SERVICE BULLETIN

SB1261A

ADDRESSEES	: Owners and users of vehicles mentioned under "Application"
VEHICLE TYPE	: T2100, C2045, CX, TX, TD925US, TDX25US, A300K, A300L, A330, AG300
CONFIGURATION GROUP	: 7.06 Steering – front-axle steering
BULLETIN TYPE	: Service Information
DATE	: June 16 th , 2015
SUBJECT	: Bevel gear of front axle steering system
TERMS & CONDITIONS	: Refer to the warranty section further in this Bulletin.

2. Procedure to remove the bevel gear

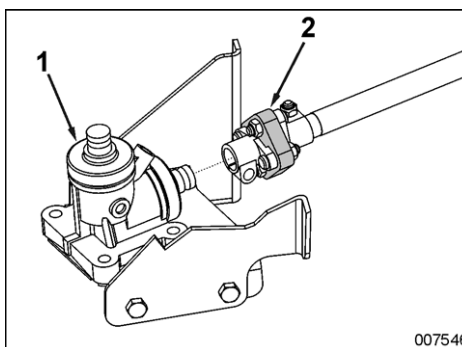
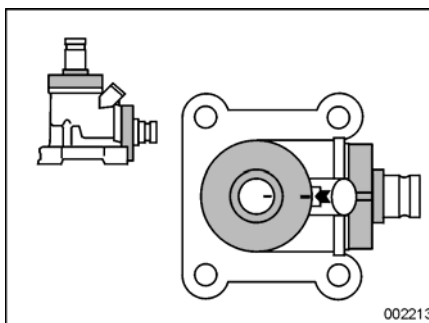
Step	Action
1	Make sure that the front wheels are in the straight-ahead position.
2	Remove the bolt of the steering column universal joint at the bevel gear.
3	Remove the bolt of the intermediate shaft elastic coupling at the bevel gear.
4	Remove the four bolts securing the bevel gear to the chassis and take away the bevel gear.

3. Procedure to check bevel gear rotating torque

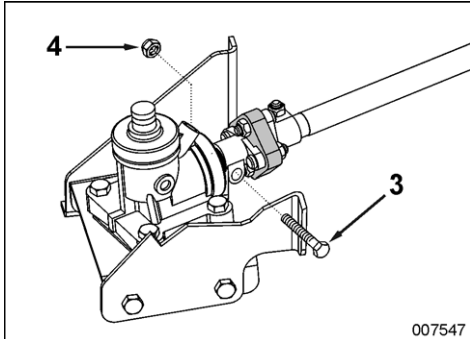
Step	Action
1	Position the bevel gear on a work bench.
2	Position a torque tester suitable for measuring small torques at the input or output shaft of the bevel gear. Check the bevel gear rotating torque by progressively increasing the force on the arm of the tester. The bevel gear must be replaced when the reading on the torque meter exceeds 0,7 Nm (0.52 ft.lbf).

4. Procedure to install the new bevel gear

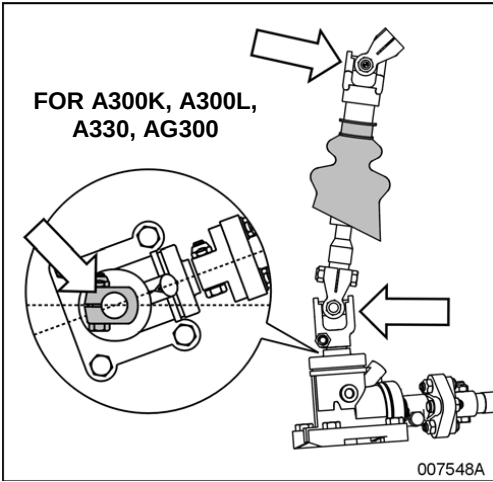
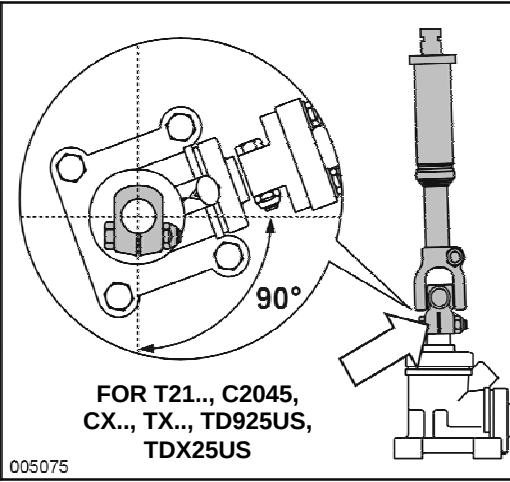
Step	Action
1	Make sure that the front wheels are still in the straight-ahead position.
2	Rotate the bevel gear input shaft to align the marks on the dust cap and on the input shaft itself with the ridge on the housing. This is the "zero backlash" position of the bevel gear.
3	Slide output shaft of bevel gear (1) into elastic coupling (2) of the intermediate shaft. Make sure that the bevel gear remains in the "zero backlash" position during this step (refer to step 2).

4	Secure the bevel gear to the chassis by using four M12 bolts with new self-locking nuts. If there are any shims found under the bevel gear on your vehicle, re-install them. Tighten the nuts to a torque of 70 ± 10 Nm (52 ± 7 ft.lbf).
5	Install clamping bolt (3) with a new self-locking nut (4). If necessary, slacken the nut of the elastic coupling clamping bolt at the intermediate shaft side to ease installation of bolt (3). 
6	Tighten the clamping bolt(s) of the elastic coupling to a torque of 48 ± 5 Nm (35 ± 3 ft. lbf).
7	Secure the universal joint of the steering column to the bevel gear with a bolt provided with a new self-locking nut. • For busses: ensure that the clamping slot of the universal joint is parallel to the longitudinal vehicle axis (as shown in the left figure). • For coaches: ensure that the clamping slot of the universal joint is perpendicular to the longitudinal vehicle axis (as shown in the right figure). Tighten the clamping bolt nut of the universal joint to a torque of 48 ± 5 Nm (35 ± 3 ft.lbf).  FOR A300K, A300L, A330, AG300  FOR T21..., C2045, CX..., TX..., TD925US, TDX25US
